TO: District of Columbia Zoning Commission

SUBJECT: Public Hearing Report for:

- 06-11Q, George Washington University Campus Plan Modification;
- 06-12Q, George Washington University First Stage PUD Modification of Significance;
- 06-11R, Further Processing for Thurston Hall; and
- 01-17E, 1959 E Street, NW Modification of Significance.

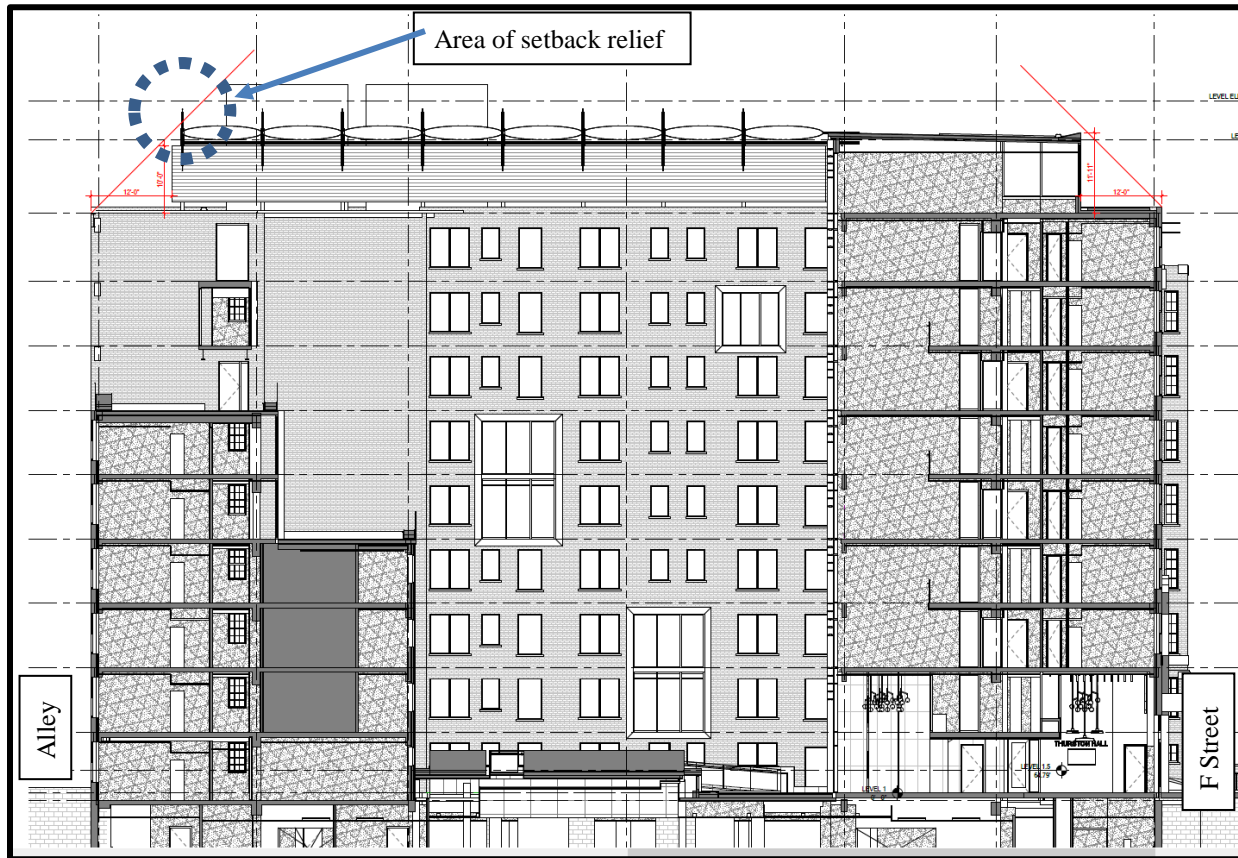
The structure supporting the canopy would not meet the required one-to-one setback from the south building wall. Please refer to the image below, which was excerpted from Case #06-11R, Exhibit 13F1, Sheet 5.

Strict application of the requirements could be interpreted to require a screen wall of 19 feet in height around all mechanical equipment at the penthouse level. Providing a single height for penthouse screening, that conceals all equipment except for the top portions of the cooling towers, would be more reasonable and would better meet the intent of this chapter by minimizing overall visibility. Regarding the penthouse structure, its slight intrusion into the 1-to-1 setback area would not be readily noticeable, especially given its location facing a private alley at the rear of the building. Based on the rendering at Sheet 44 of Exhibit 13F, it would appear that from the ground the canopy structure would not be visible at all. The location of the canopy, close to the south wall but still meeting the 1-to-1 setback for the canopy itself, would allow for maximum protection from the elements for the central courtyard, providing for the courtyard's use in three seasons out of the year.

The lower height of the screen walls would result in an overall less visible rooftop structure. The canopy support structure would slightly intrude into the 1-to-1 setback area, but would not be highly visible, if at all, from most vantage points. Neither the screen walls nor the canopy structure would appear to be extensions of the building wall.

Providing a single height for penthouse screening, that conceals all equipment except for the top portions of the cooling towers, would minimize overall visibility by providing a single 10-foot tall screen wall, rather than a 19-foot tall screen wall. The slight intrusion of the canopy structure into the 1-to-1 setback area should have no material impact in the degree of visibility of the roof structure.

The location of the canopy is governed by the desire to provide a useable, protected courtyard below. The design of the canopy itself has been pulled back from the south property line following feedback from the Commission of Fine Arts; The supporting structure, however, would still slightly intrude beyond the setback plane.

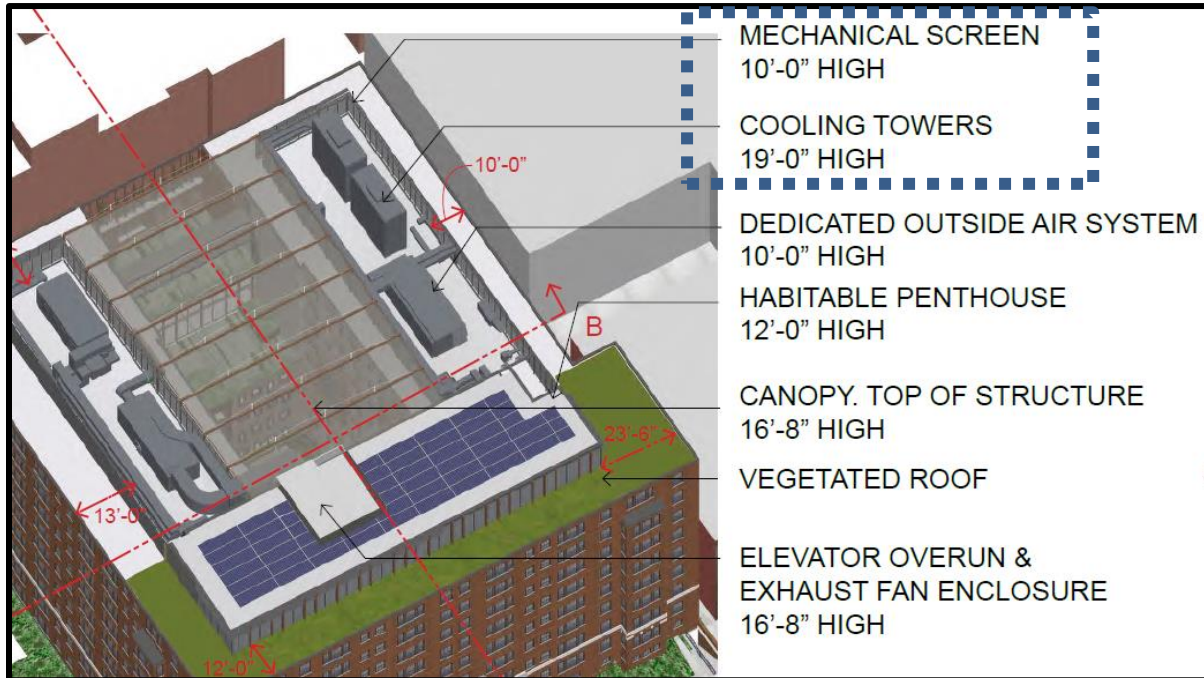
Also, the cooling towers, to be located on the southwest part of the building, would be 19 feet tall. The towers themselves meet the one-to-one setback requirement, but 19 foot tall screening walls, which must allow for air flow around the towers, would not meet the setback. The applicant has instead proposed to surround the towers with 10-foot tall screen walls, the same height as those walls screening other mechanical equipment on the roof. The 10-foot walls would meet the setback requirement, but because they would not be the same height as the cooling towers, the applicant has requested relief from C §§ 1500.8 and 1500.9. The text of those sections is below. For a rendering of the towers and the screen wall, see the image on the next page, excerpted from Case #06-11R, Exhibit 13F1, Sheet 5.

The cooling towers require adequate air circulation space around them and providing 19-foot tall walls that provide air circulation would result in an intrusion into the 1-to-1 setback at the southwest corner of the building. The proposed 10 foot walls meet the setback requirement and match the height of the other rooftop screening walls. The location of the cooling towers themselves are limited to the periphery of the site given the design of the building with a large central courtyard.

The cooling towers themselves would meet the required setbacks. 19-foot tall walls around the cooling towers, however, would not meet the setbacks. The 10-foot walls both meet the setback and provide some amount of screening for the equipment.
